Independent Assessment Report

Green Square Integrated Community Facility and School (GS ICFS)

State Significant Development Assessment SSD 10381
(Council reference D/2021/1245)

April 2022

Figure 30 | North Elevation showing location of proposed LED sign (Source: BVN)

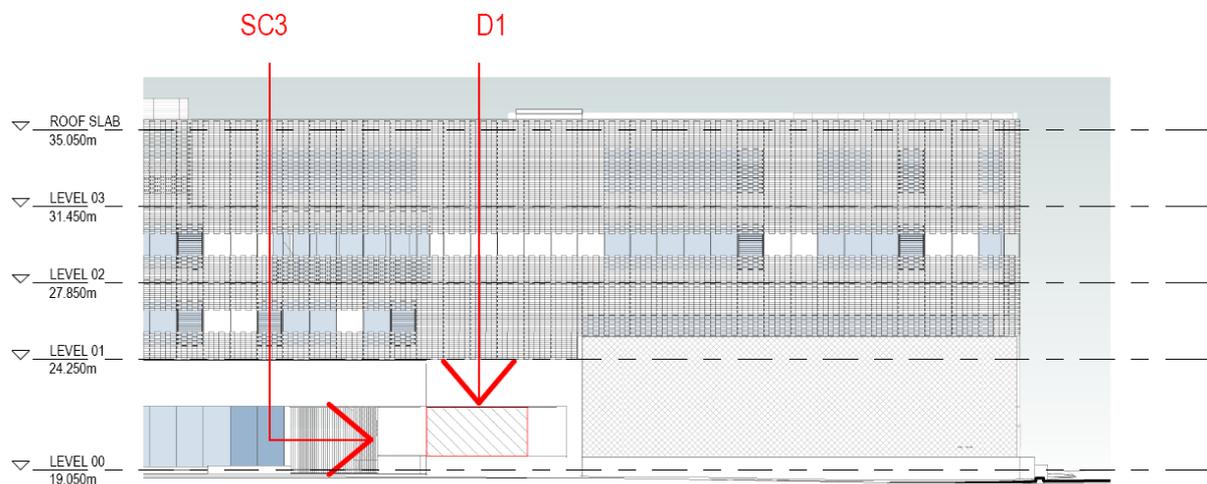
The subject application includes a proposed digital LED sign (D1) on the northern façade of the building (Zetland Avenue) adjacent to the main pedestrian entry which is proposed to be used for the purposes of school communications. The sign was original proposed with a length of 4000mm and height of 2000mm surrounded by a 12mm steel plate on all sides. The screen is to consist of 500mm x 500mm high resolution modules. Sign SC3 having dimensions of 1300mm x 330mm comprising building naming signage cast into concrete is proposed adjacent.

Following concerns raised during the initial assessment phase the Applicant amended the sign in its RtS report to 3500mm and height of 1500mm, a reduction of approximately 25%. A reduction in sign illumination was also proposed revised to 6:00am-10:00pm seven days per week.

Notwithstanding the proposed reduction in size it is still considered that the illuminated LED sign is excessive in size as proposed (having an area of 5.25m²) and that if approved, it would have an adverse visual impact on the proposed building, streetscape and wider locality. The proposed hours of operation (6:00am-10:00pm seven days per week) would also potentially result in adverse amenity impacts to residential properties in the vicinity. The sign is located on a prominent street frontage and given its excessive size has significant potential to adversely impact the public domain.
